Access Compliance Report

Public Rights-of-Way

(Curb Ramps)

Intersection ID: 49384	Main Street: SOUTH_DEVON_ST	Cross Street: SHORTHORN_ST	Location: W
ADA ID: 7D37BAFACC61	Ramp Type: Perp	Initial Pass/Fail: Fail	Overall Compliance: No
		Severity Score: 22.5	
Codes/Mitigation Info/Possible Solution		Field Measurements/Component Compliance

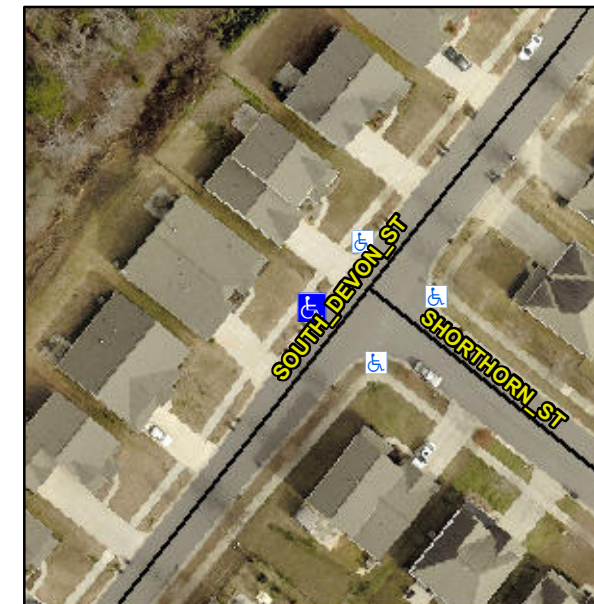
Not Found, R304.5.1, R304.2.2, R304.5.3

Compliance	Description	Data	Compliance	Description	Data
N/A	Ramp Length (in)	68.0	No	Ramp Slope (%)	8.8
No	Ramp Width (in)	47.0	No	Ramp XSlope (%)	3.1
N/A	Flare Type LT	N/A	N/A	Flare Type RT	N/A
N/A	Flare Slope LT (%)	N/A	N/A	Flare Slope RT (%)	N/A
N/A	Flare Traversable LT?	N/A	N/A	Flare Traversable RT?	N/A
N/A	Landing Length (in)	N/A	N/A	DWS Provided?	N/A
N/A	Landing Width (in)	N/A	N/A	DWS Contrast?	N/A
N/A	Landing Slope (%)	N/A	N/A	DWS Length (in)	N/A
N/A	Landing X Slope (%)	N/A	N/A	DWS Full Width?	N/A
N/A	Landing Curb? (Y/N)	N/A	N/A	DWS Offset (in)	N/A
N/A	Shared Landing?	N/A			
N/A	Gutter Ponding?	N/A	N/A	Gutter Slope (%)	N/A
N/A	Gutter Lip Ht (in)	N/A	N/A	Gutter X Slope (%)	N/A
N/A	Painted X Walk1?	No	N/A	Painted X Walk2?	N/A
	X Walk 1 Direction	To SE		X Walk 2 Direction	N/A
N/A	X Walk 1 Width (in)	N/A	N/A	X Walk 2 Width (in)	N/A
	X Walk 1 Slope (%)	1.9		X Walk 2 Slope (%)	N/A
	X Walk 1 X Slope (%)	2.7		X Walk 2 X Slope (%)	N/A

Remove & Replace Entire Ramp.
